# Access Compliance Report

## Public Rights-of-Way

### (Curb Ramps)

Intersection ID: 10022634	Main Street: CARMEL_RD	Cross Street: N/A	Location: NE
ADA ID: 1CEBB04F9BA2	Ramp Type: PerpDiag	Initial Pass/Fail: Fail	Overall Compliance: No
		Severity Score: 12.5

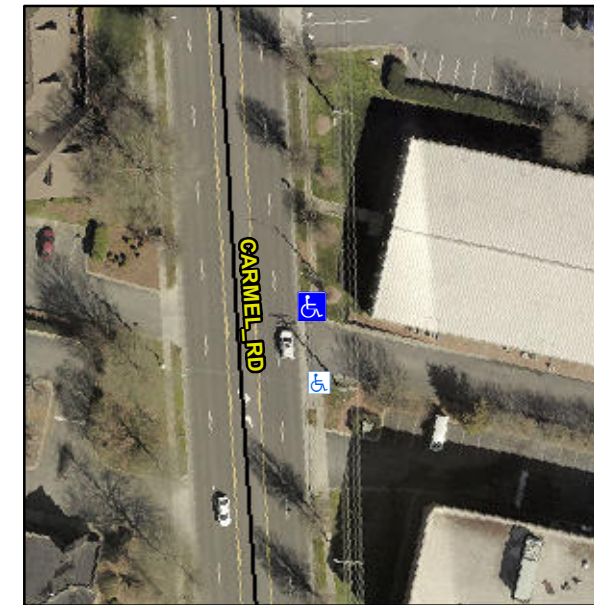
**Not Found, R304.2.2**

Compliance	Description	Data	Compliance	Description	Data
N/A	Ramp Length (in)	73.0	No	Ramp Slope (%)	9.6
Yes	Ramp Width (in)	48.0	Yes	Ramp XSlope (%)	0.9
N/A	Flare Type LT	N/A	N/A	Flare Type RT	N/A
N/A	Flare Slope LT (%)	N/A	N/A	Flare Slope RT (%)	N/A
N/A	Flare Traversable LT?	N/A	N/A	Flare Traversable RT?	N/A
N/A	Landing Length (in)	N/A	N/A	DWS Provided?	N/A
N/A	Landing Width (in)	N/A	N/A	DWS Contrast?	N/A
N/A	Landing Slope (%)	N/A	N/A	DWS Length (in)	N/A
N/A	Landing X Slope (%)	N/A	N/A	DWS Full Width?	N/A
N/A	Landing Curb? (Y/N)	N/A	N/A	DWS Offset (in)	N/A
N/A	Shared Landing?	N/A			
N/A	Gutter Ponding?	N/A	N/A	Gutter Slope (%)	N/A
N/A	Gutter Lip Ht (in)	N/A	N/A	Gutter X Slope (%)	N/A
N/A	Painted X Walk1?	No	N/A	Painted X Walk2?	No
	X Walk 1 Direction	To W		X Walk 2 Direction	To S
N/A	X Walk 1 Width (in)	N/A	N/A	X Walk 2 Width (in)	N/A
	X Walk 1 Slope (%)	2.6		X Walk 2 Slope (%)	2.6
	X Walk 1 X Slope (%)	0.6		X Walk 2 X Slope (%)	0.8

**Remove & Replace Curb Ramp With Two New Directional Ramps or Equivalent.**
